**CITY COUNCIL
SITE PLAN REVIEW SHEET**

CASE NUMBER: SPC-2025-0018C **COUNCIL MEETING DATE:** July 24, 2025

PROJECT NAME: ACCX - Convention Center C2

Site Plan Application – Master Comment Report

RE: Separation Waiver Request – UCM 2.9.1 (B)
ACCX – Site Plan (SPC-2025-0018C)
4201 South Congress Avenue
Austin, Travis County, Texas, 78745

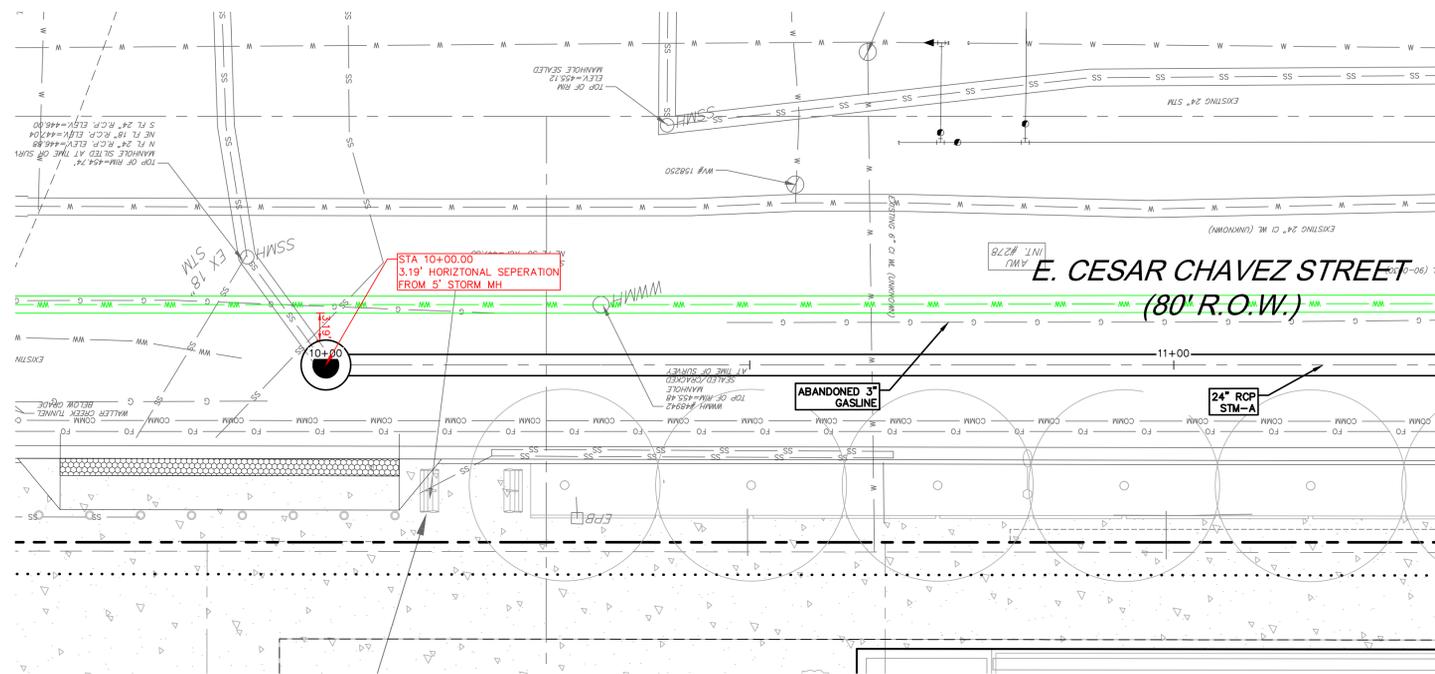
This project is requesting a waiver from Section 2.9.1 (B) of the City of Austin Utility Criteria Manual, which requires a minimum horizontal separation of 5 feet between existing or proposed AW infrastructure and all other non-AW infrastructure to maintain trench integrity.

This waiver is necessary due to having to place a 24" RCP storm drain within a narrow street corridor (E. Cesar Chavez Street) with multiple existing underground utilities within a tight confined area. The area of interest can be found on sheet 67, STORM A PLAN & PROFILES STA 10+00 - 11+75, and can be seen as 3.17 LF separation from the existing 24" wastewater line to the 5' storm manhole at 10+00.00 STM-A. For the reasons stated above we ask that you approve this waiver from UCM Section 2.9.1 (B).

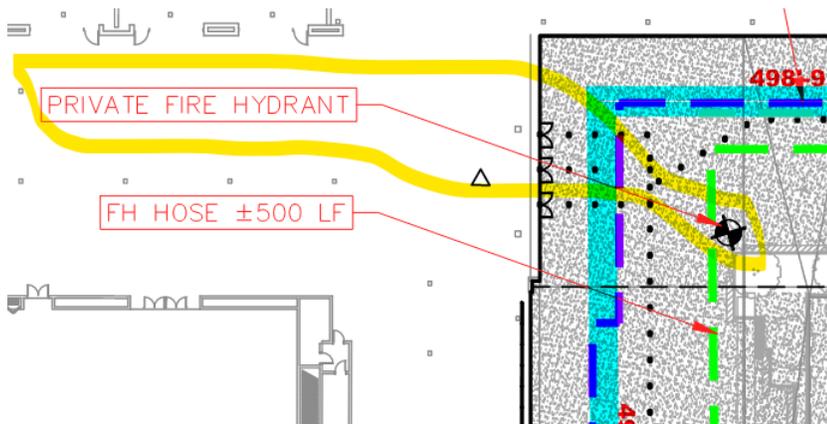
F2: 2021 IFC 503.1.1 Fire Apparatus Access Roads – Where Required - Buildings and Facilities. (UPDATE 2 COMMENT – FYI ONLY) Upon discussion with engineering and operations staff, comment is cleared. No AMOC is required as 503.1.1 allows approval under prerequisite conditions.

Approved fire apparatus access roads shall be provided for every facility, building or portion of a building hereafter constructed or moved into or within the jurisdiction. The fire apparatus access road shall comply with the requirements of this section and shall extend to within 150 feet (45 720 mm) of all

portions of the facility and all portions of the exterior walls of the first story of the building as measured by an approved route around the exterior of the building or facility.

IW1 – Current Status: Pending

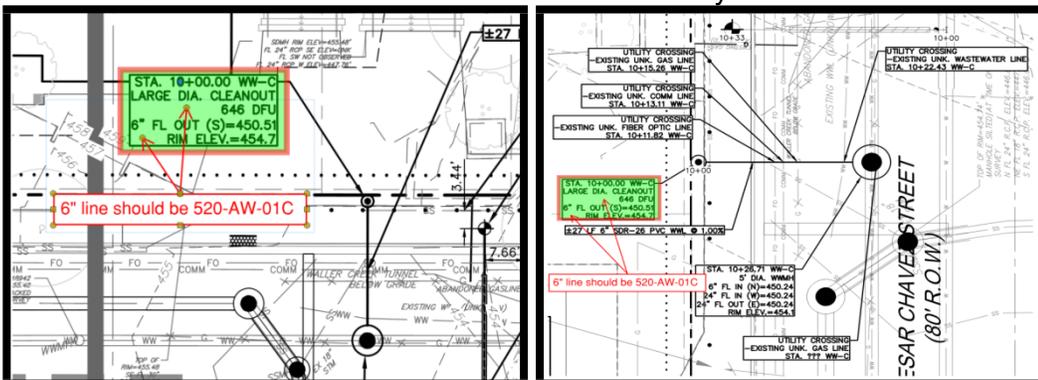
- **U2: Not Addressed - Sheet 82, Utility Plan D & Sheet 96, Wastewater A, B & C Plan and Profiles: WW-C is a 6" line. Please update the sample port call out to reflect the standard detail 520-AW-01C and include the detail in the utility detail sheets.**

- **U1: Sheet 76, Utility Plan D & Sheet 88, Wastewater A, B & C Plan & Profiles:** WW-C is a 6" line. Please update the sample port call out to reflect the standard detail 520-AW-01C and include the detail in the utility detail sheets.

- For compliance with §15-10-226 of the Austin City Code and UCM 2.9.4.G.5, install a City of Austin approved single riser **2-way cleanout** per Standard Detail 520-AW-01C to act as a sampling and inspection port.
- Reference the detail in the call-out and include the detail in the utility detail sheets.
- Per UCM 2.9.4.G.7, the cleanout must be located at or near the property line within the public right-of-way (ROW) or utility easement line.
- The cleanout **shall not** be located in a vehicle traffic area, parking area, load bearing pavement, sidewalk, or driveway.
- Standard Detail 520-AW-01C applies within public ROW or utility easement line.
